CONNECTION ASSESSMENT & APPROVAL PROCESS ASSESSMENT SUMMARY

**Project: Cardinal Substation – Modification of
115kV Substation**

CAA ID: 2002 – EX071

Date: December 19, 2002

Figure 1: Enbridge Cardinal Station 115kV Connection Facilities

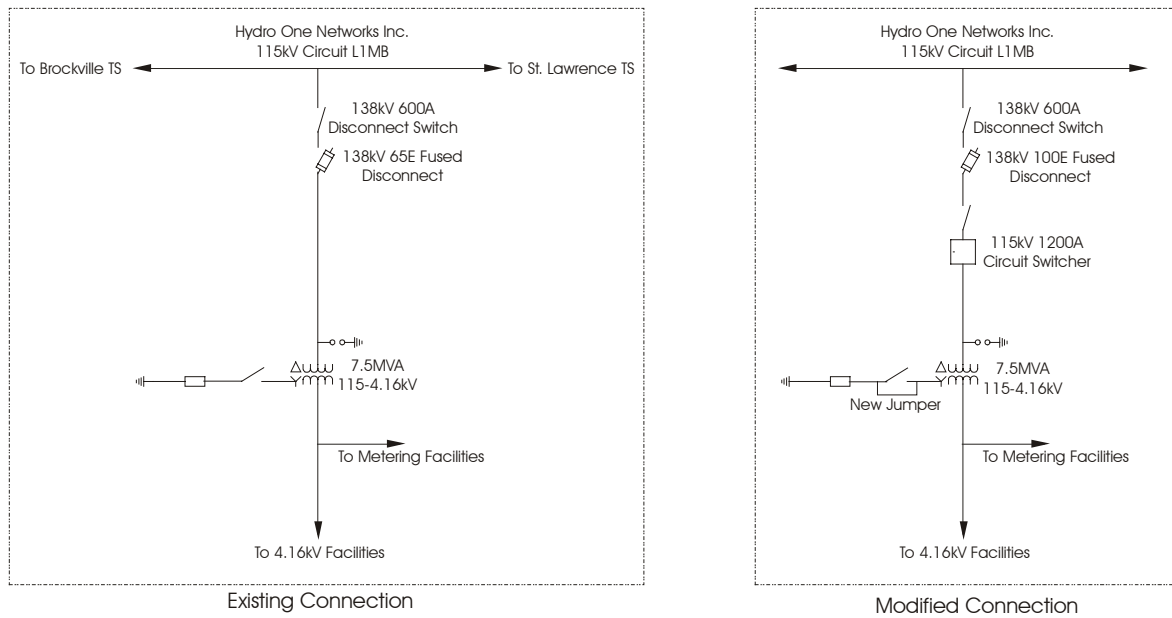
Both the disconnect switch and the fused disconnect are rated at 138kV. Although the new circuit switcher has a nominal voltage rating of 115kV, the manufacturer S&C Electric has indicated that the device is capable of operating at a maximum voltage of 145kV.

The primary protective device at the substation is the new 115kV circuit switcher. The fused disconnect provides back-up protection if the circuit switcher fails to operate in response to a contingency. The circuit switcher has a short circuit rating of 25kA and the rating of the fuse cutout is determined by protective relay setting co-ordination.

Based on information from Hydro One Networks Inc., the maximum 115kV fault level at the Cardinal substation is less than 10kA. The new 115kV circuit switcher is adequate with enough margin for fault level increases due to future development in the area. However, the Transmission System Code specifies that all new 115kV equipment and system elements connected to the transmission system shall, as a minimum, be capable of interrupting a maximum fault level of 50kA. It should be noted that should any future development in the area by a third party increase the fault level at the Cardinal substation beyond the 25kA rating of the circuit switcher. The subsequent replacement of the circuit switcher at Cardinal substation might well be the responsibility of Enbridge Pipelines inc.

With the existing arrangement, any fault involving the 7.5MVA transformer will result in the tripping of the 115kV circuit L1MB. Other customers connected to L1MB would be affected. After the implementation of the proposed plan, the new circuit switcher would clear any fault involving the transformer while the circuit L1MB would remain in service resulting in better system reliability.

Based on the above assessment, it is recommended that a Notification of Approval for the proposed modification to the Cardinal substation be issued to the applicant.
